TERMINALS
SHEATH MOUNTED TERMINALS
LOCATING

NOTES CONCERNING THIS ADDENDUM

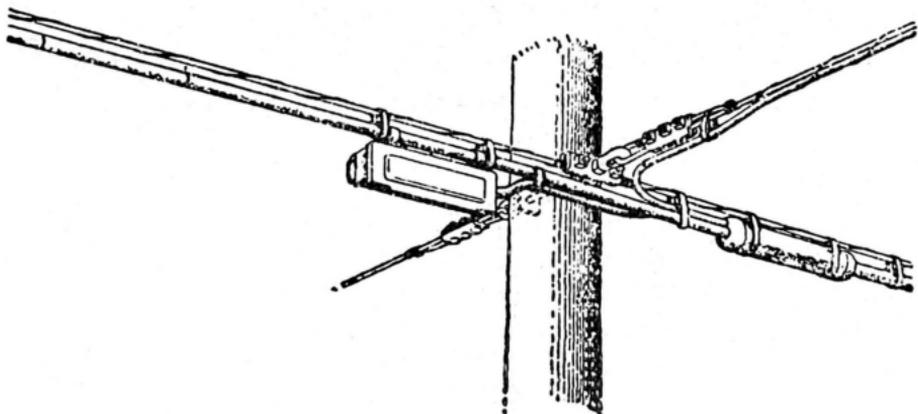
2.09 At false dead end poles, where space between the pole and the nearest 3-bolt clamp will not permit locating the terminal in accordance with Paragraph 2.01 and 2.02, the terminal may be mounted under the clamp as shown in the following illustration.
